Technical Note TN8

F80 internal-fuse replacement for use with i80

Fuse to be replaced

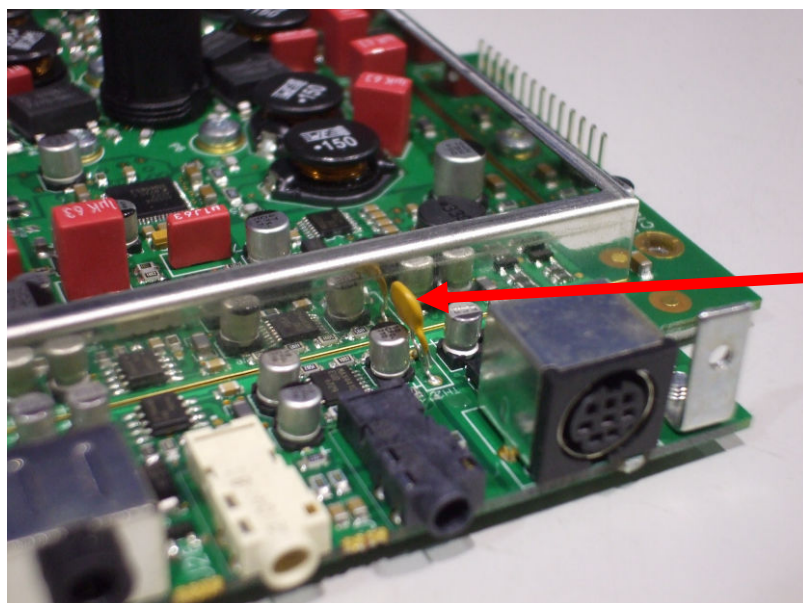
F80s with serial numbers lower than 10004000 require a modification to allow the product to charge an iPod® when used in conjunction with i80.

The modification requires an internal fuse to be exchanged for an uprated type. This fuse is a small yellow disc-like component soldered onto the main PCB. The F80 must be disassembled in order to carry out the modification. Disassembly instructions are available from Meridian on Technical Note **TN9**.

Once the main PCB has been removed, the relevant component can be found close to the multi-way "Mini-DIN" socket used for connection to the i80.

The uprated fuse can be obtained from Meridian using the following part-number and/or description:

C20136 - fuse polyswitch 0.3 amp
